Eastleigh Borough Council Tree Preservation Order and Conservation Area Assessment Form

Application Number	T/26/101770
Surveyor	IF
Address	12 COULTAS ROAD, CHANDLER'S FORD, EASTLEIGH, SO53 5BE
Proposed work	2 no. Silver Birch (T1 & T2) - Crown raise up to 6m and crown reduction by 2-3m. Overhanging driveway and has not had any maintenance since 2020. 1 no. Turkey Oak (T3) - Crown lift to 6m and crown reduction by 2-3m. Remove epicormic growth from trunk and canopy. Overhanging Malcolm road and the garden 1 no. Pedunculate Oak (T6) - Crown lift 6m with crown reduction by 2-3m. Overhang getting closer to the house. All are in good health. Full survey done by CBA in 2022 and they provided some advice for future health hence the request.
Assessment Date	20.08.2026
Officer comments	TPO 251-E G26 (5no. Birch) – T1 and T2 in the application, G28 (2 no. Oak) T3 in the application, T80 (1no. Oak) T6 in the application. Corner plot with all of the trees subject to the proposal being highly visible in the public realm and adding to the verdant character of the area. 2no. Birch to the front of the property framing the driveway, some signs of low vitality and some deadwood present in the crown

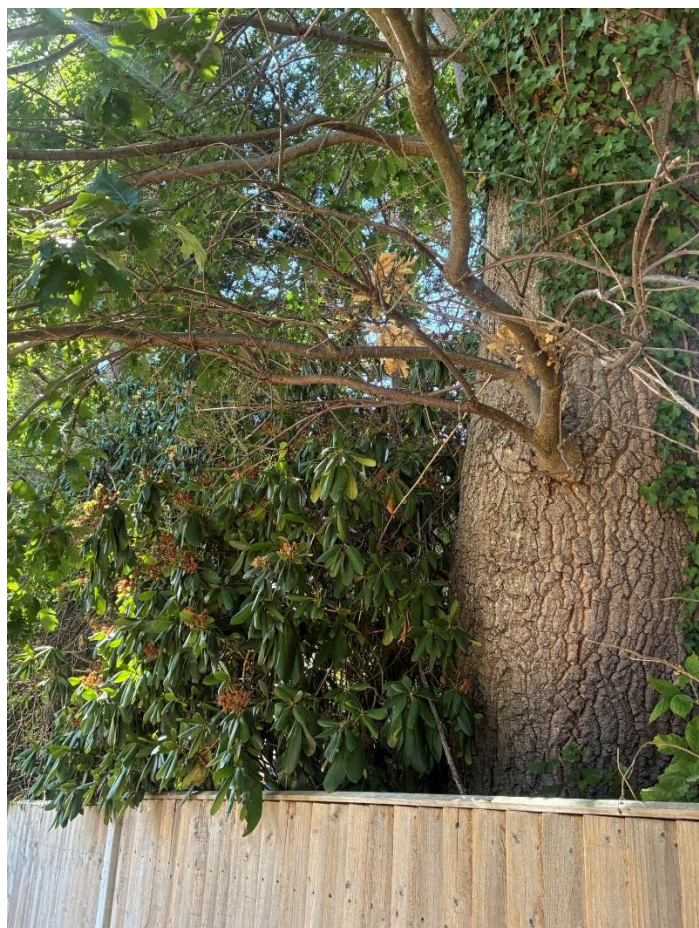
proposal is not considered justified at present based on the application submitted and in the absence of evidence to support the proposed works such as defects or poor health of the tree, direct conflict with built structures etc.					
Decision	Consent	Refuse	Part consent/ Part refuse	Withdrawn / Invalid	Conservation Area	
					Raise no objection	TPO
				X		
Decision notice	Refuse: 2 no. Silver Birch (T1 & T2) - Crown lift to 6m. 1 no. Turkey Oak (T3) - Crown lift to 6m and crown reduction by 2-3m. 1 no. Pedunculate Oak (T6) - Crown lift 6m. Consent to: 2 no. Silver Birch (T1 & T2) - Crown lift to 3.5m and crown reduction by 2-3m. 1 no. Turkey Oak (T3) - Remove epicormic growth from trunk and canopy. 1 no. Pedunculate Oak (T6) - Crown lift to 3.5m, crown reduction by 2-3m.					
Conditions						
Notes to applicant	Deadwood can be removed without planning permission.					
Parish comments	None received.
